ERL High Energy e^+e^- sub-Panel Report

This caused the formation, in agreement with the LDG, of a sub-Panel to evaluate the prospects (primarily luminosity), involved R&D, and the schedule and cost consequences for the ERLC.

The sub-Panel was also asked to evaluate the concept to configure the FCC-ee as a high luminosity circular energy recovery collider, CERC (<https://doi.org/10.1016/j.physletb.2020.135394>), with the same criteria.

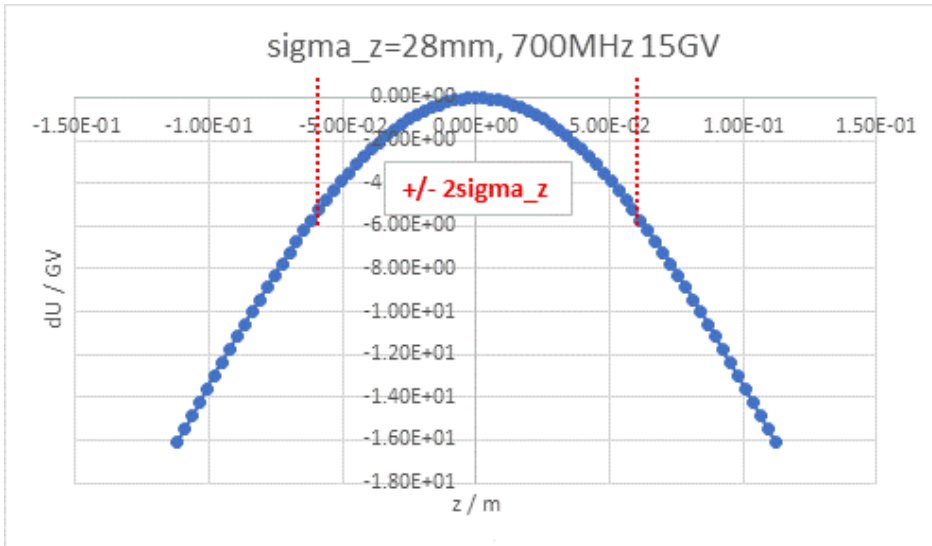
frequency system is advantageous in this context and an improvement of the RF field flatness can be achieved by adding a higher harmonic system with a voltage opposite to the main ERL RF. For the example of a 350MHz 1st harmonic system the situation is depicted in the figure below. Assuming that the FFS requires an energy deviation

from the on-crest particle of not more than 1% for the core of the beam ($\pm 2\sigma_z$) in order to avoid an increase of the beam size at the IP (this could be more relaxed with a wide-band FFS), the maximum tolerable bunch length is 10mm. When adding a 3rd harmonic system with 11% of the voltage of the 1st harmonic system, a bunch length up to 28mm would be tolerable (see 2nd figure below). Note that in that case also the 1st harmonic voltage has to be increased by 11% to maintain the full beam energy.

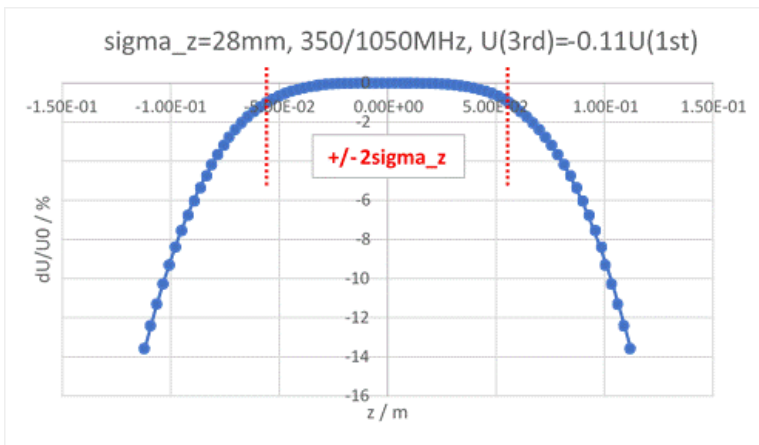
However, the 2nd harmonic system, which is designed to compensate the radiative energy loss, creates a non-linear energy profile which is not compensated. The bunch energy profile for a 700MHz system with a 15 GV

voltage is shown in the figure below for a bunch length of 28mm. The energy deviation with respect to the on-crest particle amounts to about -5GV at +/- 2 σ_z which is obviously a serious problem for the damping ring energy and energy acceptance. One could also consider adding a 3rd harmonic system here, but

at 2.1GHz it will be very difficult to handle HOM problems and furthermore the energy variation in the tails of the longitudinal bunch distribution becomes too large. Therefore, one can conclude that a bunch length of much more than about 10mm does not seem to be realistically feasible.
